## Accessibility Survey

### City of Downey Cornuta Avenue - Foster Road to Angell Street

Date of Inspection  
12/10/2016

Prepared By  
**Disability Access Consultants**  
(800) 743-7067

**Tree South Of Imperial Highway Service Road @ 33.914817473, -118.118793368340**

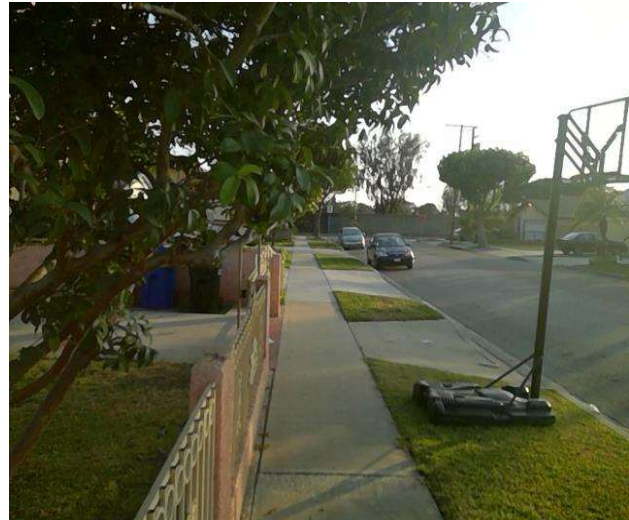
Sidewalks , Hazards & Gratings : Overhead Obstruction Height

Overhead obstruction height is not compliant.

**On-Site Finding** 62.00 inches

Provide a compliant vertical clearance height.

Recommendation At least 80.00 inches

#### Change In Level North Of Cheddar Street @ 33.915485585735, -118.118956983089

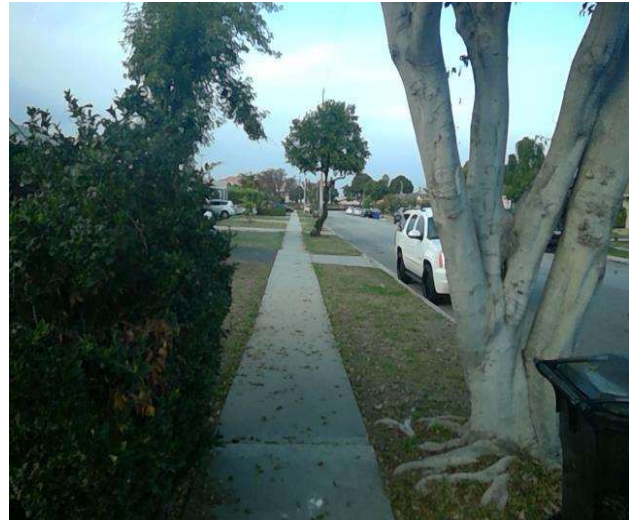
Sidewalks , Change in Level : Change in Level Non Beveled

There is a change in elevation greater than recommended value.

**On-Site Finding** 0.62 inches

Ensure that the change in elevation is within the recommended value.
